## CITY of NOVI CITY COUNCIL

**Agenda Item D**  
**December 8, 2014**

**SUBJECT:** Approval of Ordinance No. 14-124.19, Chapter 11 "Design and Construction Standards", Articles XI "Bicycle Paths", and Article XII "Pedestrian Safety Paths" and Ordinance No. 14-45.30, Appendix C of the City of Novi Code of Ordinance, Article VI, "Design Standards", Section 4.05, "Pedestrian Safety Paths, Bicycle Paths and Public Walkways" in order to amend the existing design and construction standards to incorporate the Engineering Design Manual standards for off-road non-motorized facilities and to repeal conflicting Design and Construction Standards for Bicycle Paths, Pedestrian Safety Paths and public walkways. **SECOND READING**

**FIGURE XI**

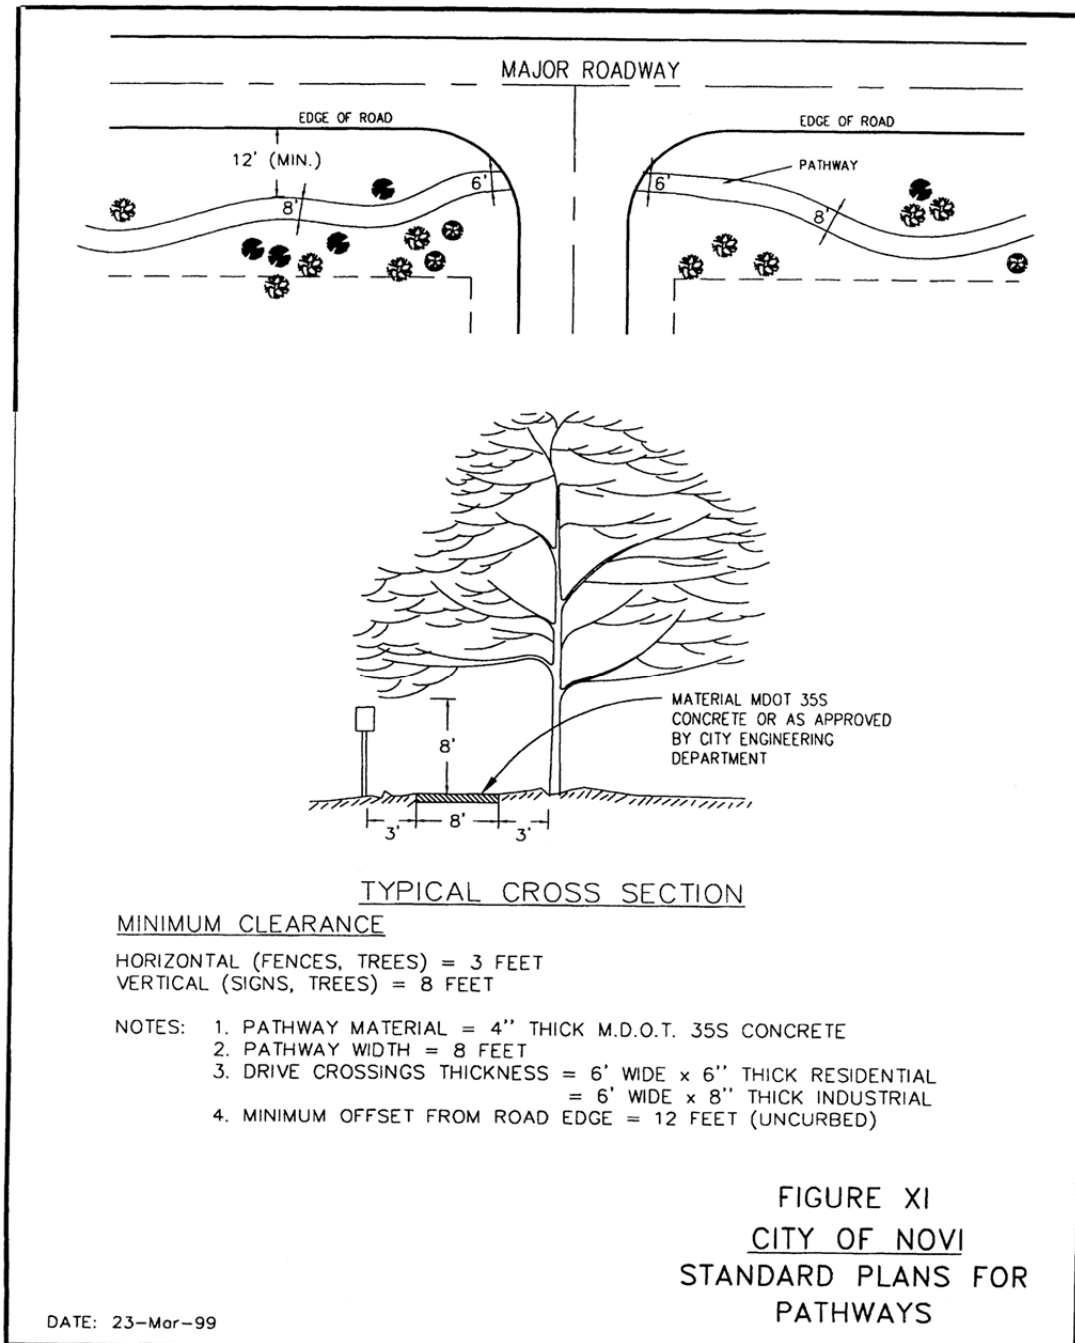
~~(h) — Minimum horizontal and vertical clearances shall be in accordance with Figure XI except that where bicycle paths are built or rebuilt in an area that contains trees greater than six (6) inches d.b.h., a separation of four (4) feet from said trees shall be provided wherever feasible. Where the path must be closer than four (4) feet to such a tree, a physical barrier or herbicide impregnated barrier cloth must be placed under the path to prevent the tree roots from heaving the path. The area requiring the barrier shall include any portion of the path following within the points as set forth in section 11-~~
